Bulletin Number - BP2A - 01

Project	Steamboat I	Base Village Re	devel	opment		Date 05/26	/2021	
Project Location	Steamboat,	Colorado				Architect's Pro	ject Number 03.7	835.000
Owner/Client	Alterra Mour	ntain Company	/ Eas	t West Partners	S	File 6BL T	his is page 1 of	
То	Saunders Co	onstruction Inc.				Attention B	ryan Sculthorpe	
Address	86 Invernes	s Place North						
City	Englewood					State CO	Zip 80112 Code	
Delivered via:	П	Messenger	П	Hand carried	П	Facsimile		
Denvered via:		Express		Pick-up		E-mail Address		
		Mail		UPS		Website Address	BIM360	
This Bulletin Convey	s to Contractor (Check one of the fo	ollowing	g five choices.):				
Architect's Author		or Changes to the Work as des	cribed	below.				
		mental Instruction				, ,	ntal Instructions form	•)
Architect's Confir This confirms Archi Note: The above the is/are issued in acco	tect's verbal instr ree choices are ea	ructions to (individu ach subject to the fo	al's nar ollowing	me) on (date g terms: The change	e), a: e(s), clarific	s described below. ation(s) and/or confir	mation(s) described b	RCRBI

General: This bulletin addresses clarifications to Gold Walk's door schedules, door hardware, and room numbering for pe

B-D3.101

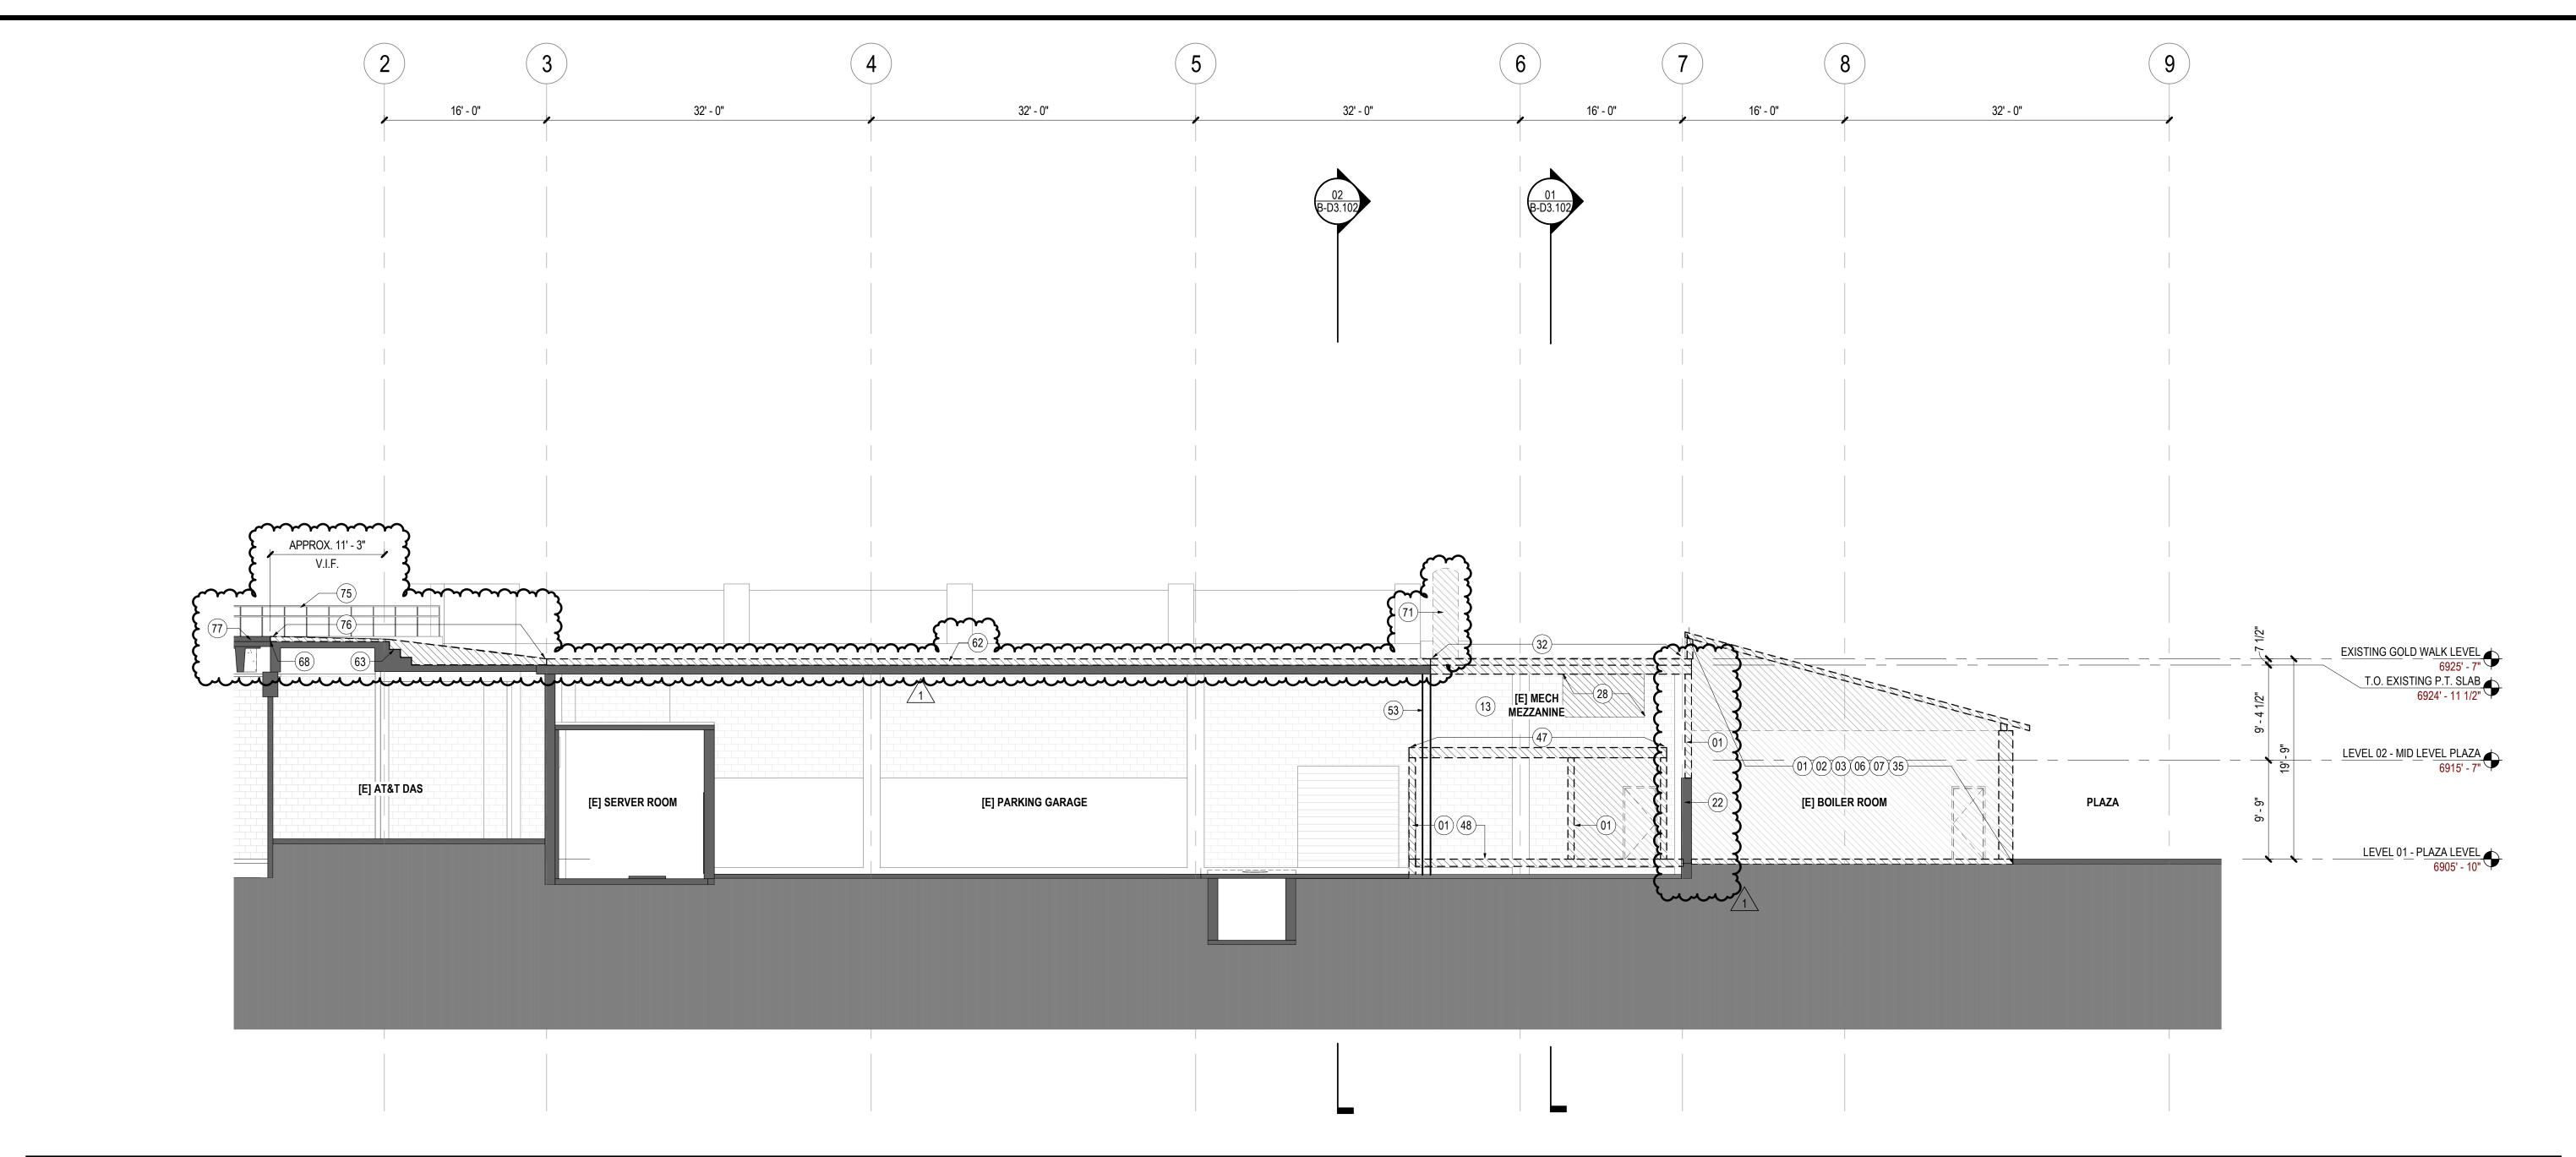
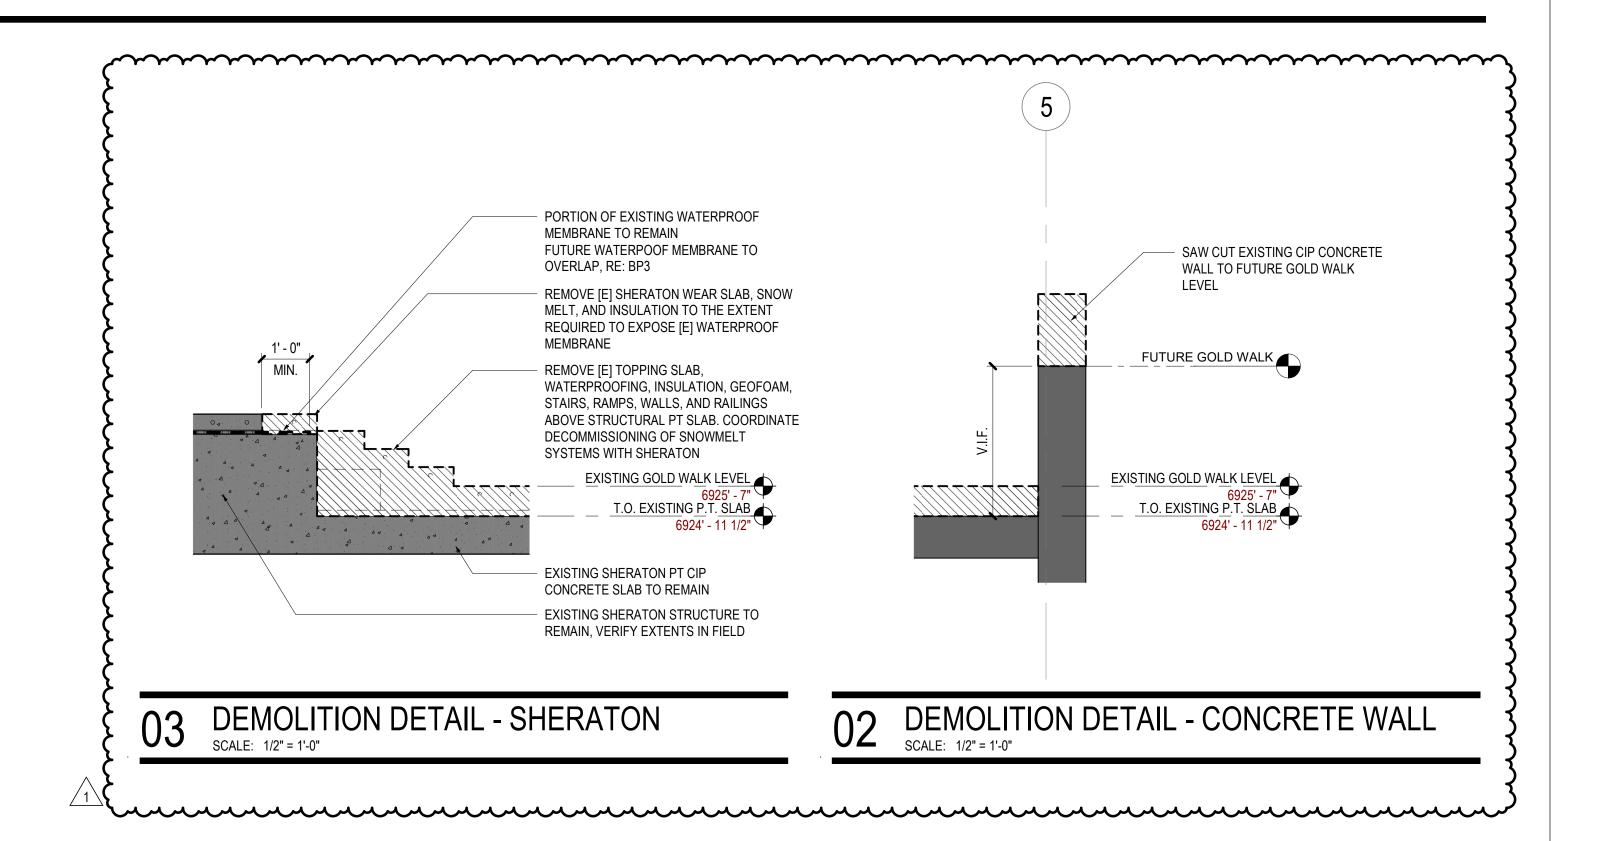
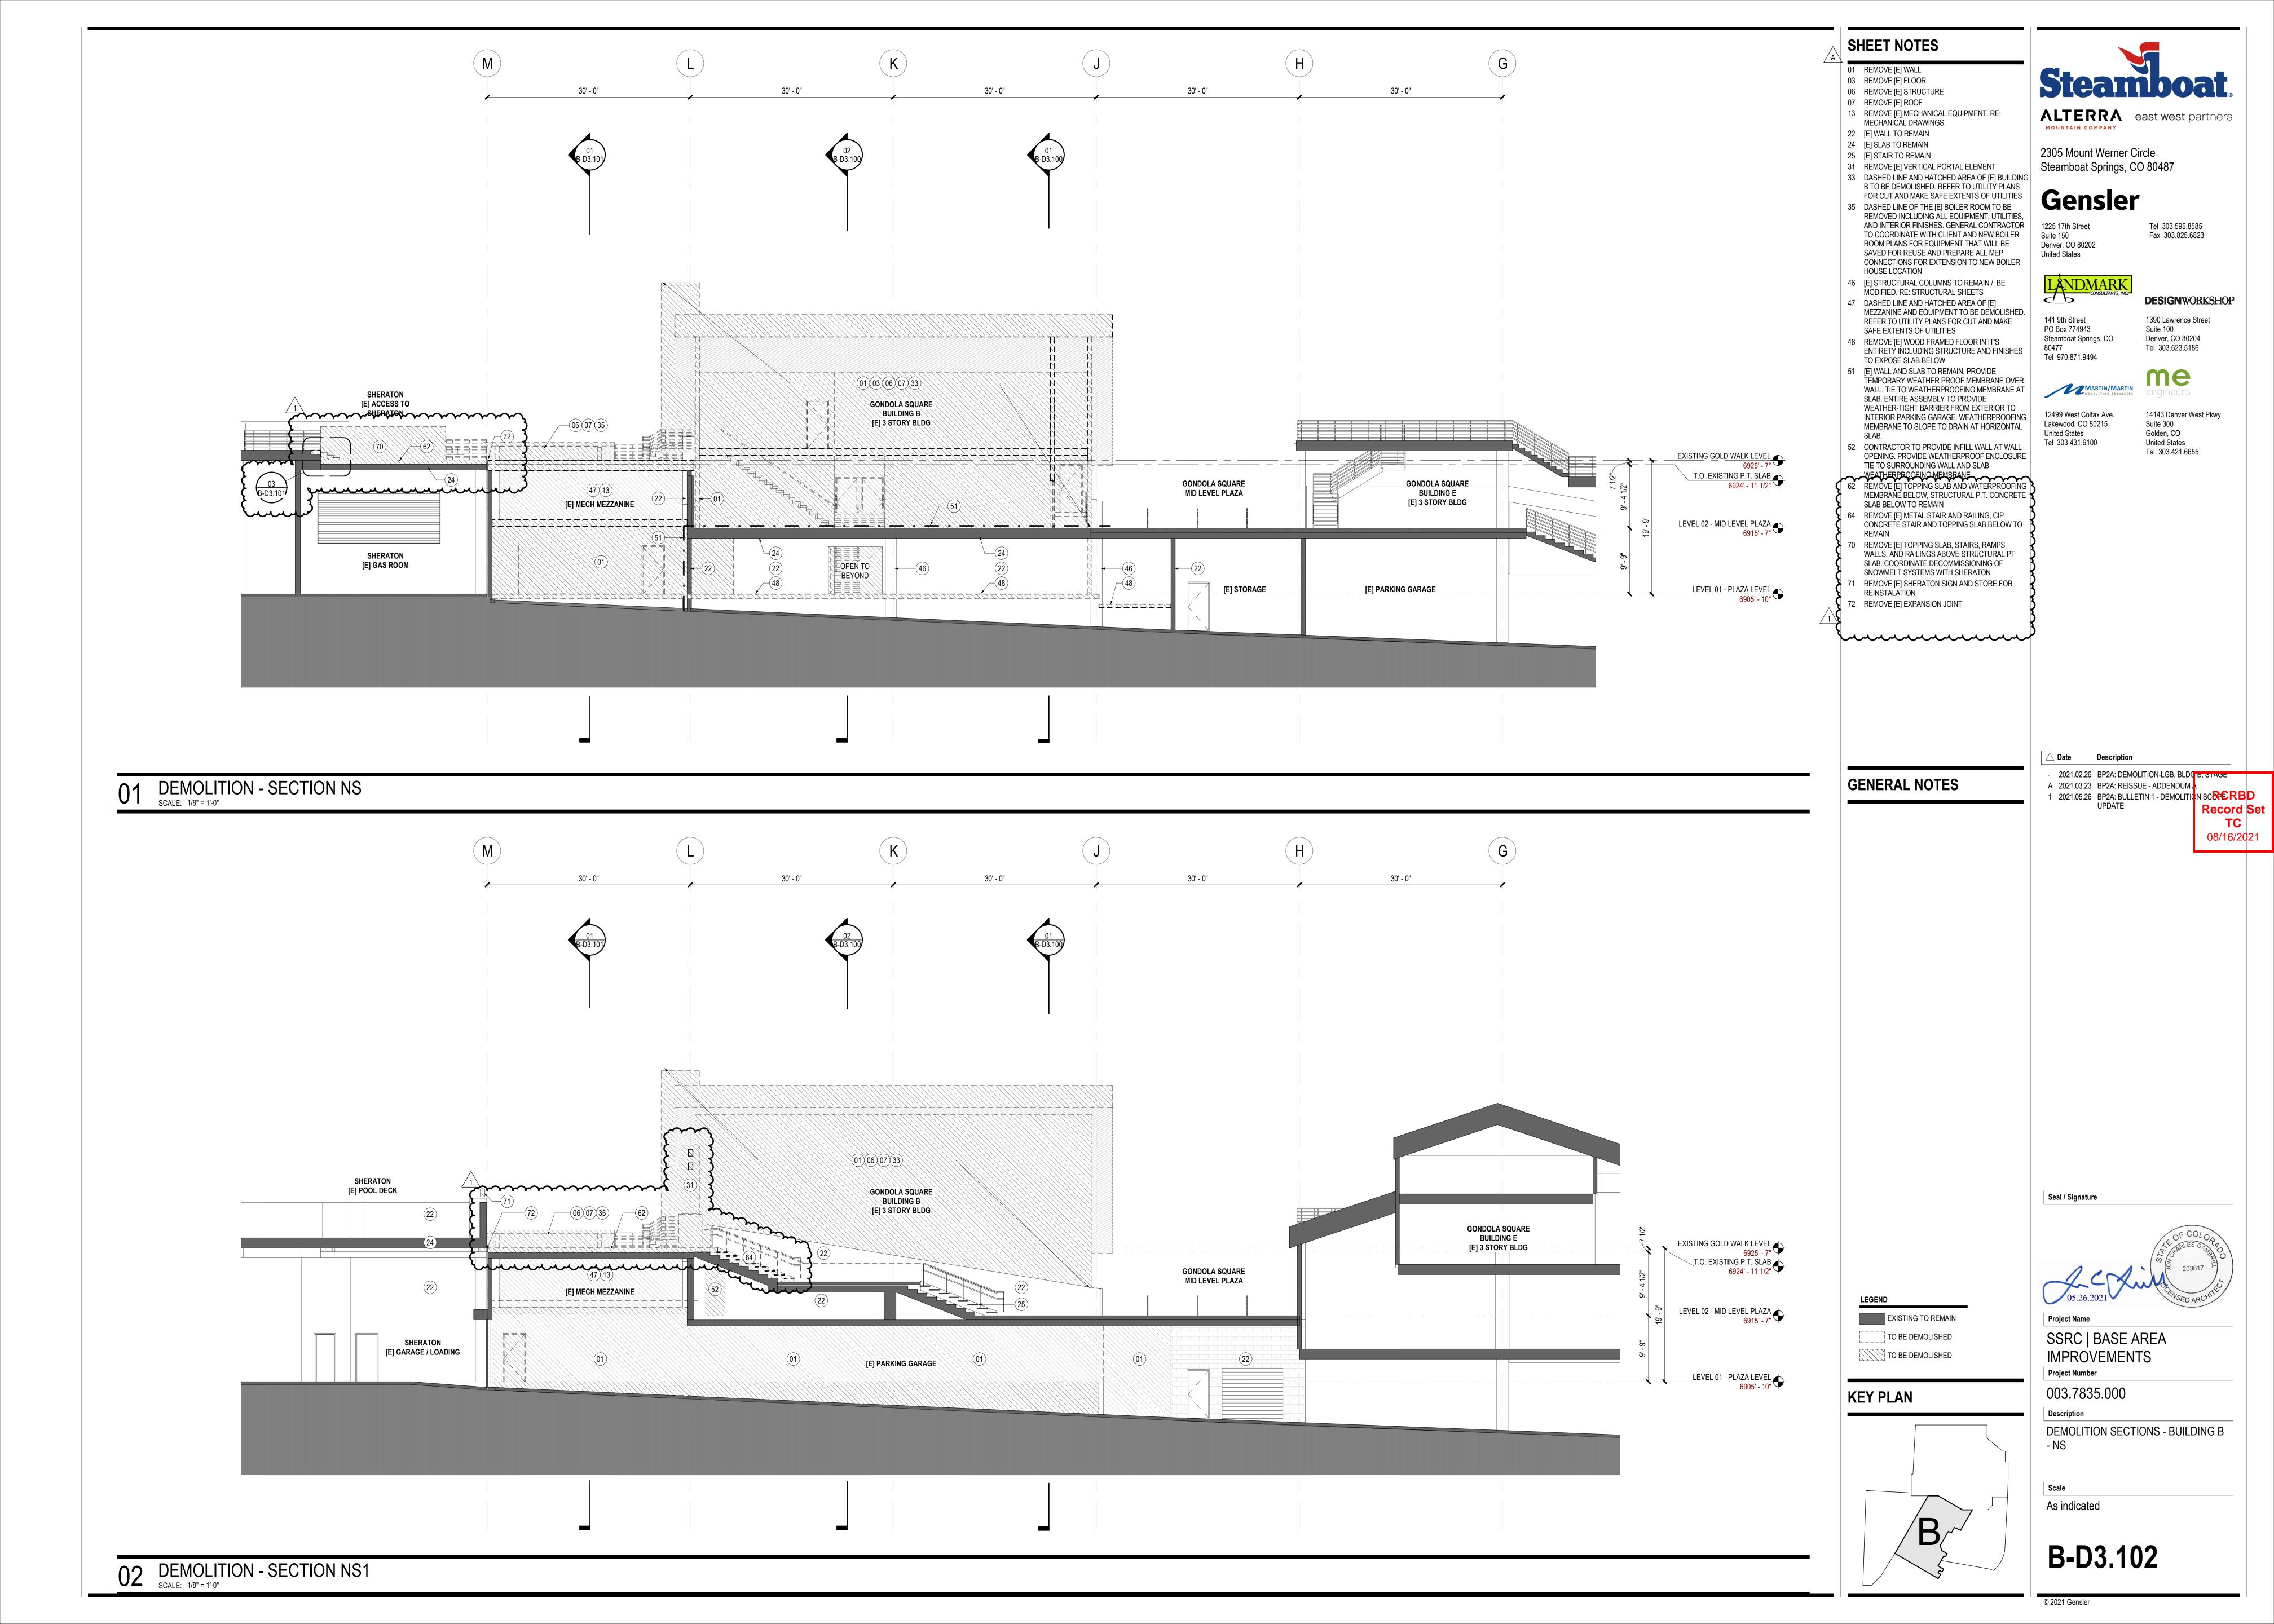
- c. Sheet notes Added notes #62 and 64-67
- 10. B-D3.101 DEMOLITION SECTIONS BUILDING B EW
 - a. 01 DEMOLITION SECION EW 3
 - i. Added topping slab removal

- ii. Added CMU wall removal
 - iii. Clarified existing conditions
 - iv. Added Sheraton scope
 - b. Added Demolition Details 02 & 03
 - c. Sheet Notes Added notes #22, 62, 63, 68, 71, and 75-77
